Department of Energy
Carlsbad Area Office
P. O. Box 3090
Carlsbad, New Mexico 88221

June 26, 2000

[PLANS TO RAISE THE REPOSITORY HORIZON] aug 2/6/04

Investigation of the Advantages of Removing Highly Fractured Roof Beams

Figure 3-2. Plan View of WIPP Underground Facility and Panel Closure Systems

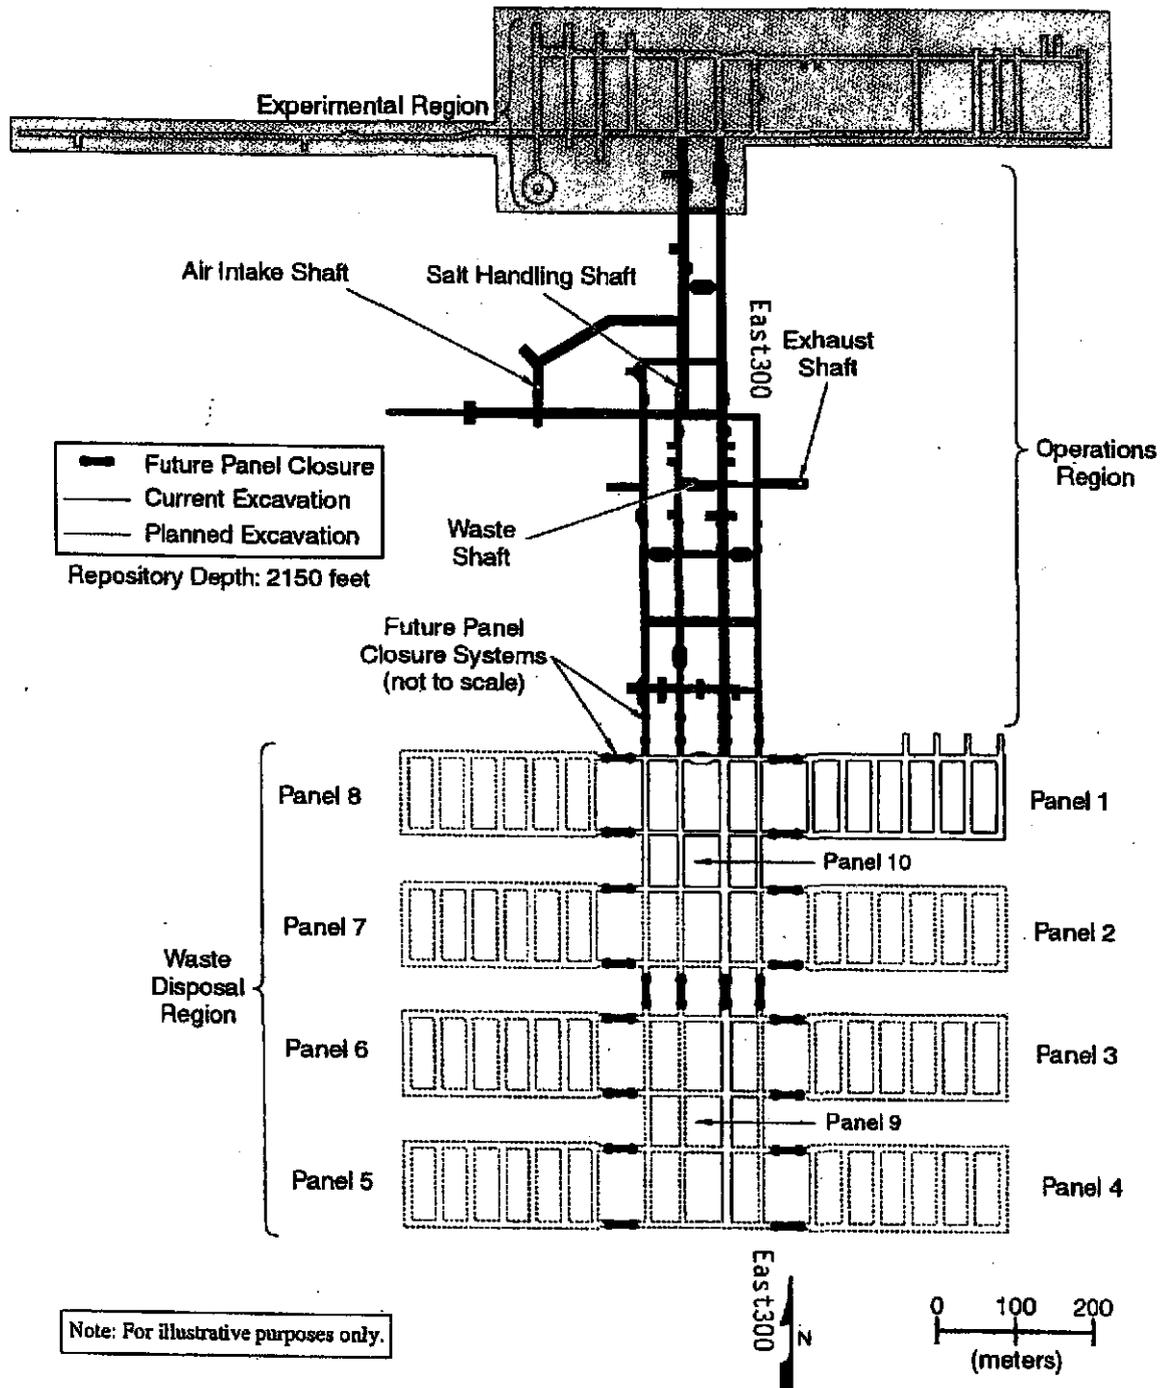
The repository horizon for Panels 3, 4, 5, 6, and 9 will be raised so that the roof is at clay seam G (shown on the attached Figure 3-6). Raising the repository horizon will be initiated in the East 300 drift (shown on the attached Figure 3-2) which leads into Panel 3. Raising the repository horizon now and in this location will result in improvements in safety and in operational efficiencies. This does not imply that there are underground safety concerns associated with the present situation; however, by raising the repository horizon by about two meters, ground conditions will be improved and considerably less maintenance will be required to assure optimum ground conditions.

Figure ES-1
Typical Facilities-Typical Disposal Panel
(After Westinghouse, 1995c)

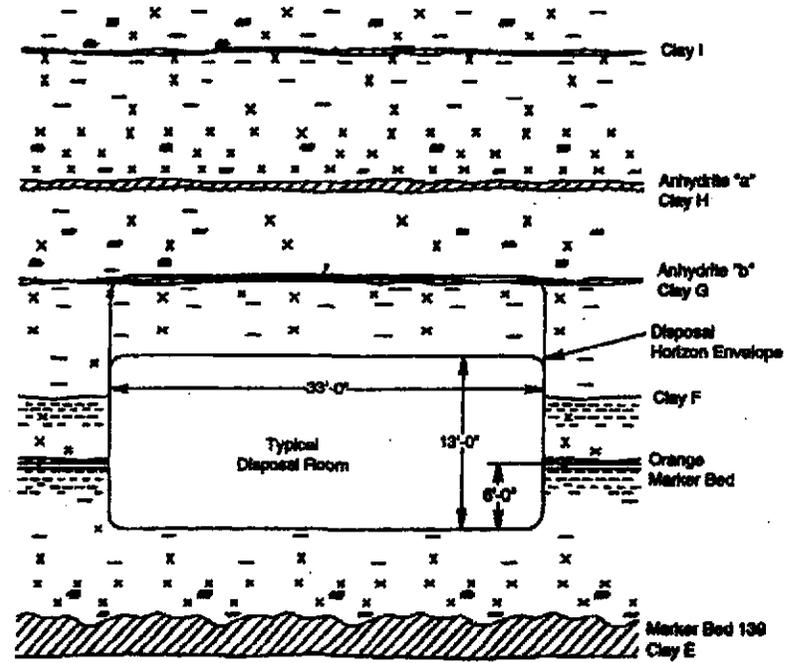
expected to be quite small and may only be observable, if observable at all, in the subsystem performance assessment (PA) computer codes. More importantly, it is expected that there will be an insignificant impact on the location of the Complementary Cumulative Distribution Function (CCDF) curve for the PA that was included in the Compliance Certification Application (CCA) and the Performance Assessment Verification Test. This insignificant impact on the CCDF is expected because of the simplifications and conservative assumptions (e.g., treatment of the disturbed rock zone (DRZ) and panel closure permeability) made in the PA-scale computer models regarding the repository horizon and long-term performance of the disposal system. This change in repository horizon is within the disposal horizon envelope presented in the CCA in Figure ES-1 of Appendix Panel Closure System (PCS) and in Figure 3-6 from Chapter 3.
